UNITED STATES  
DEPARTMENT OF THE INTERIOR  
BUREAU OF LAND MANAGEMENTFORM APPROVED  
OMB NO. 1004-0135  
Expires: July 31, 2010**SUNDRY NOTICES AND REPORTS ON WELLS**  
*Do not use this form for proposals to drill or to re-enter an abandoned well. Use form 3160-3 (APD) for such proposals.*

8. Well Name and No. **<25523>**  
EMPIRE 20 FEDERAL COM 29. API Well No.  
30-015-31046-00-D110. Field and Pool, or Exploratory  
TURKEY TRACK11. County or Parish, and State  
EDDY COUNTY, NM**SUBMIT IN TRIPLICATE - Other instructions on reverse side.**

**WORKOVER PROCEDURE**  
**Empire 20 Fed Com #2**  
**API # 30-015-31046**

# Empire 20 Fed Com #2 - Proposed

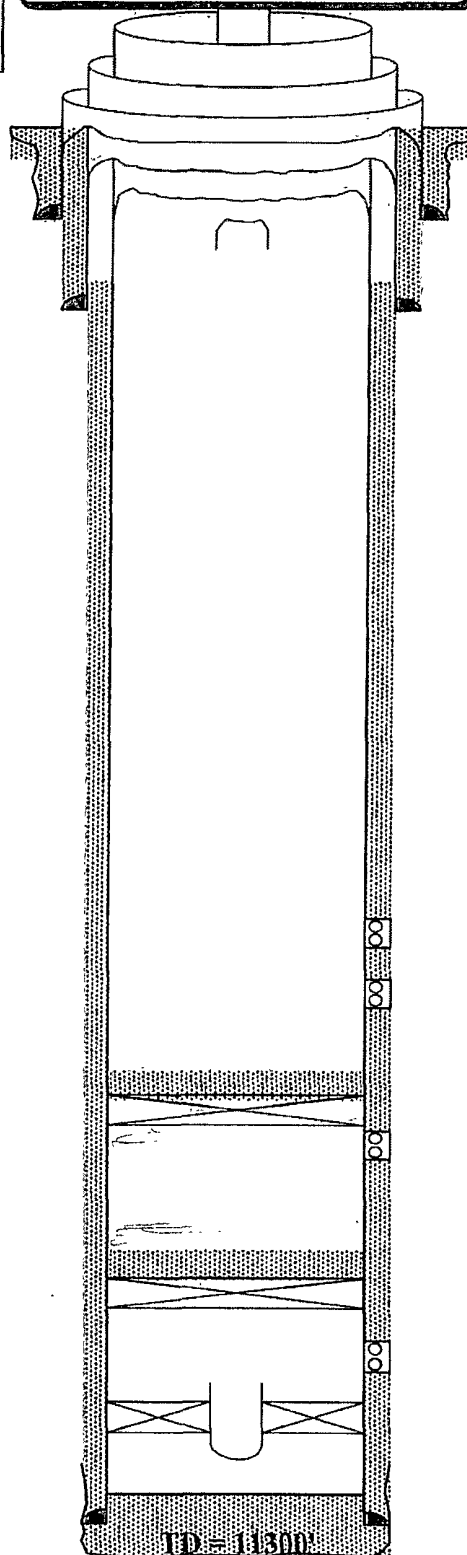
1. Class H cement must be used when placing cement on the CIBP's.
2. Surface disturbance beyond the originally approved pad must have prior approval.
3. Closed loop system required.
4. Operator to have H2S monitoring equipment on location as H2S has been reported from wells in the area.
5. Subsequent sundry with completion record and wellbore schematic required.
